Motion #1: Adopting the Sept. 14, 2012 Draft ERC Regulating Plan with amendments as follows:

April 25, 2013 Approved Amendments to the Sept. 14, 2012 Draft ERC Regulating Plan

MARCH 7, 2013 SUMMARY SHEET**Approved Amendments to the Sept. 14, 2012 Draft ERC Regulating Plan****Council Action, Amendments, Group A:**

Figure 1-3: East Riverside Corridor Roadway Type Map

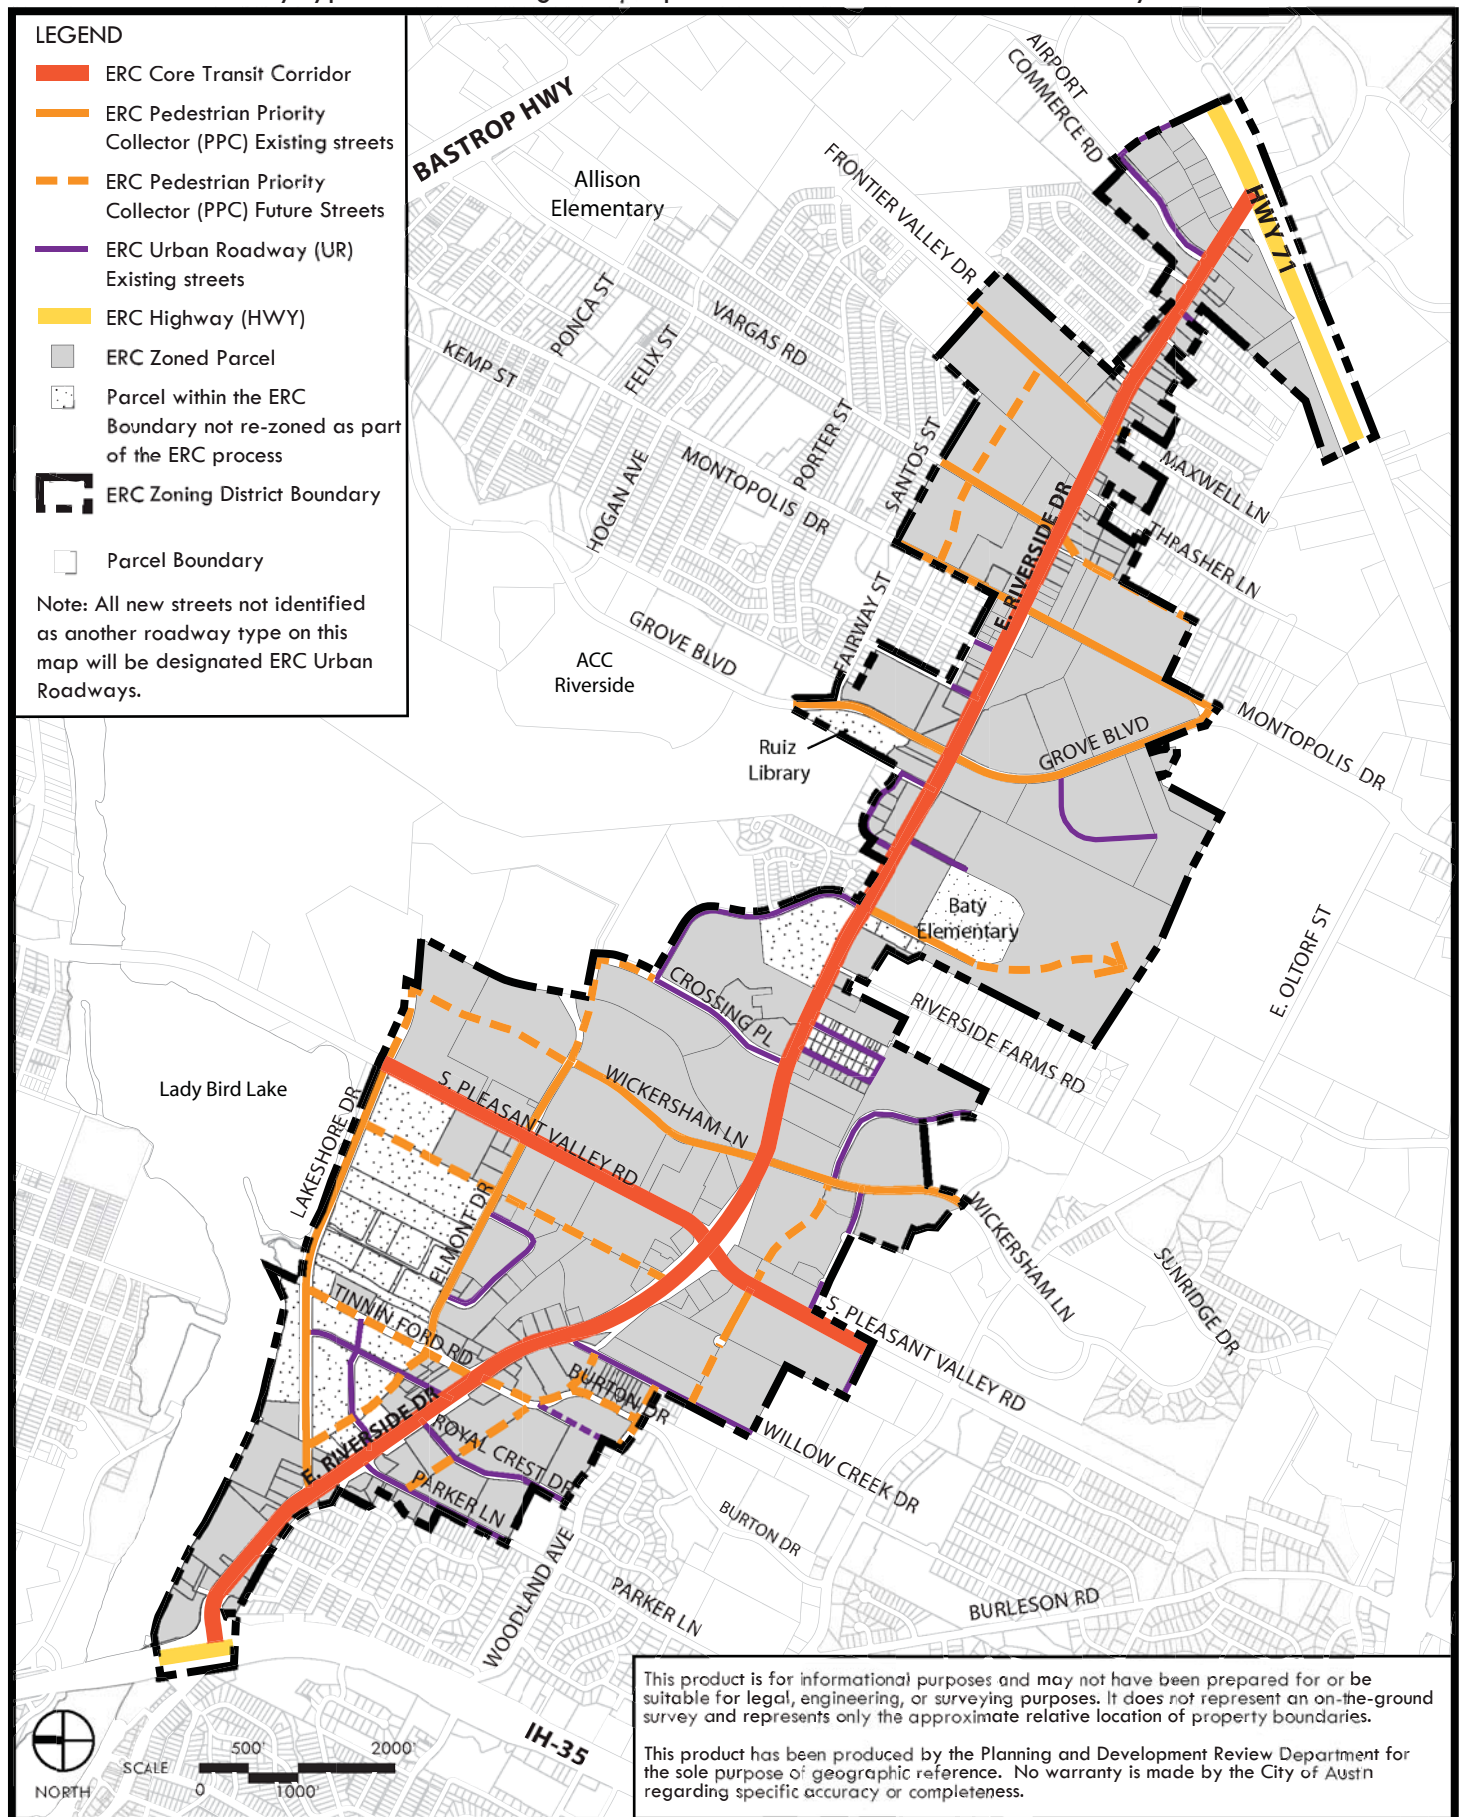
- C.2. P. 15, Modification to collector street map to account for an existing drainage way. See revised Figure 1-5: East Riverside Corridor Collector Street Map (Nov. 8, 2012 DRAFT – see attached) and associated Figure 1-3: East Riverside Corridor Roadway Type Map (Nov. 8, 2012 DRAFT– see attached).

Indicates the Roadway type for all existing and proposed streets within the ERC boundary.

Shows existing and new streets designated as Collector streets.

Figure 1-14: East Riverside Corridor (ERC) Future Land Use Map (FLUM)

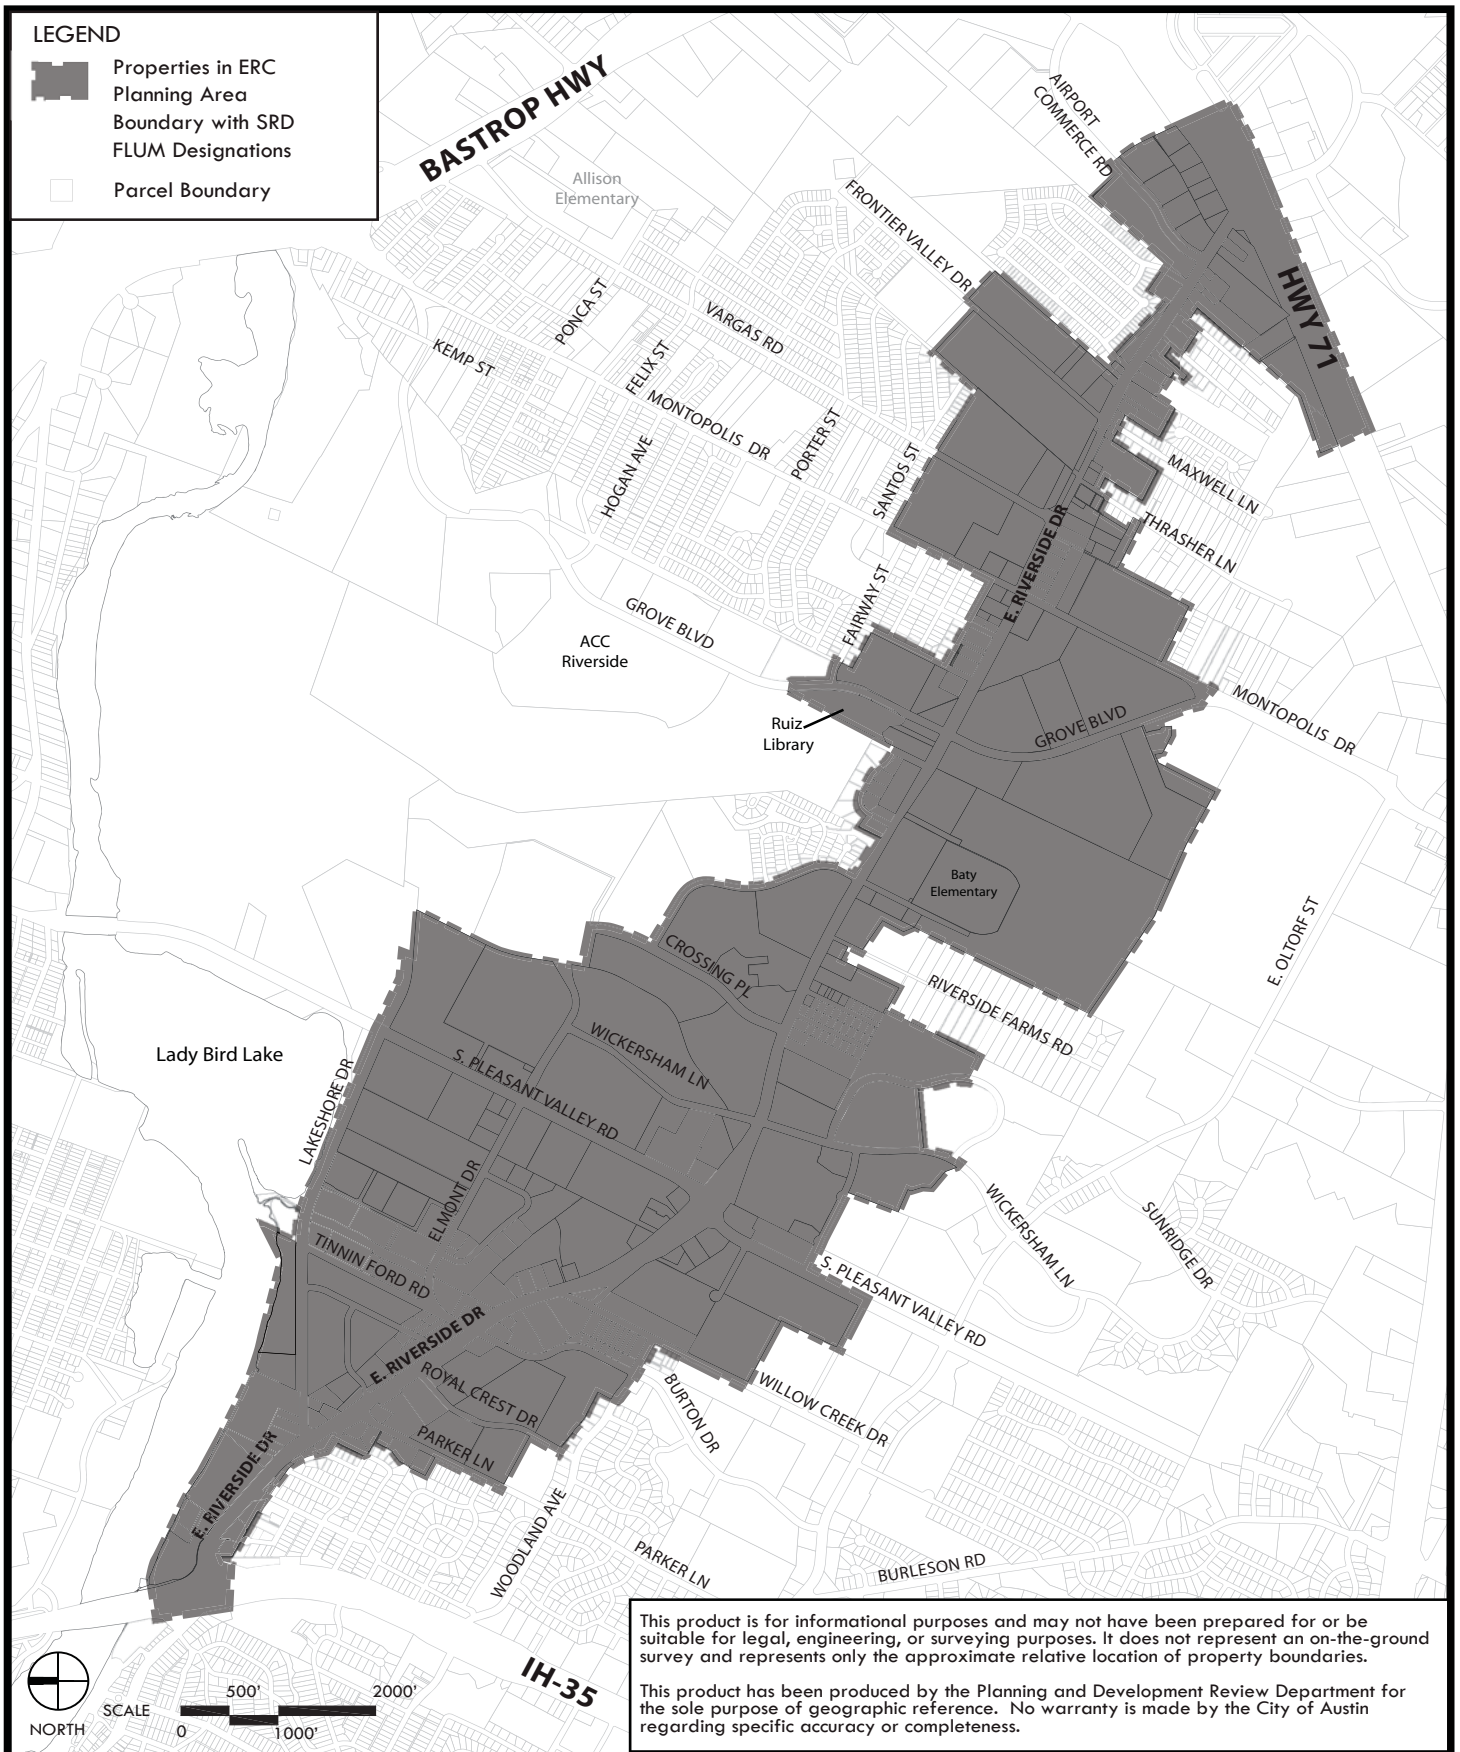
- A.3. P. 24. Add new Figure 1-14: East Riverside Corridor (ERC) Future Land Use Map (Nov. 8, 2012 DRAFT – see attached) (**Note:** Added for clarification purposes.)

The map below indicates the properties within the ERC planning boundary with the Specific Regulating District (SRD) FLUM designation.

Figure 4-1: Two Story Minimum Requirements

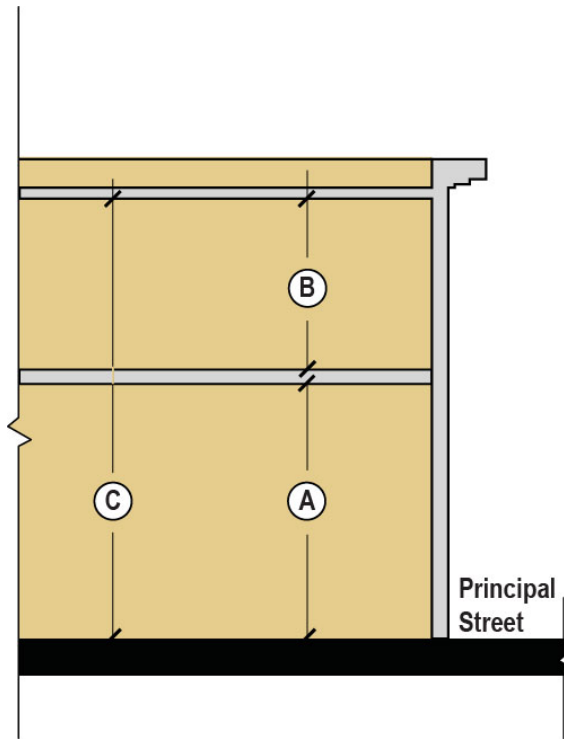
- A.5. P. 55, figure 4-1: Two Story Minimum Requirements. Replace figure with Nov. 8, 2012 Draft. (**Note:** Changed to make figure more understandable – see attached.)

Figure 1-15: Map of Properties with Drive-Through Facilities as of [adoption date, 2013].
 Map of properties to which Subsection 2.3.5.B (Drive-Through Facilities) applies.

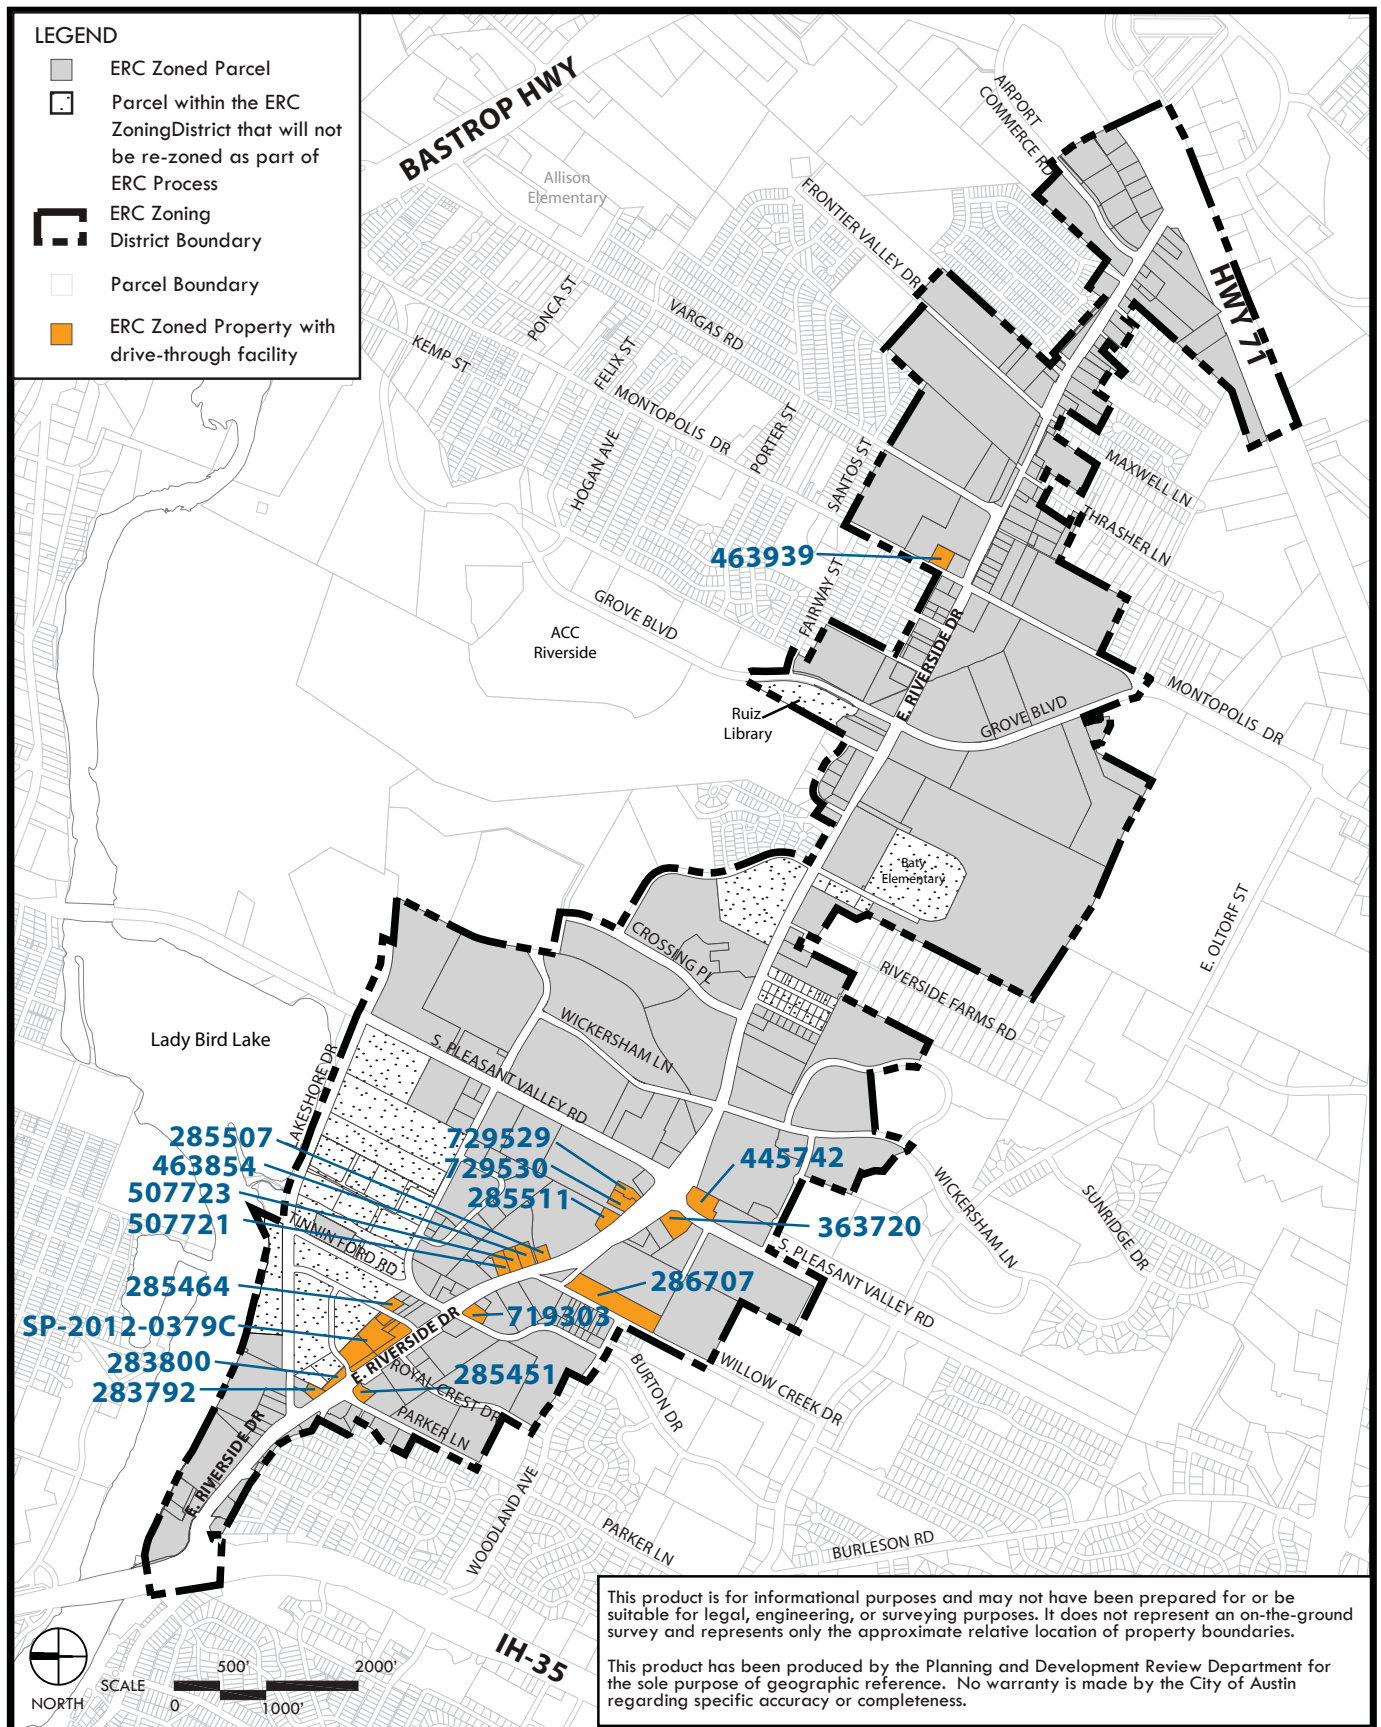
- D.1 P. 27, Subsection 2.3.5.B (Drive-Through Facilities) – Delete the text of Subsection B and replace with the following: “A property containing a drive-through facility legally constructed or permitted prior to [insert ERC Regulating Plan adoption date], is not subject to this Subsection 2.3.5.A. Construction on said properties can include the replacement of a drive-through facility, but construction will be subject to all standards in the ERC Regulating Plan according to the applicability standards in Section 1.2 Applicability. The number of drive-through bays or lanes cannot be increased from those existing as of the above date.” (**Note:** Staff deemed the original Subsection B language section repetitive and unnecessary.)
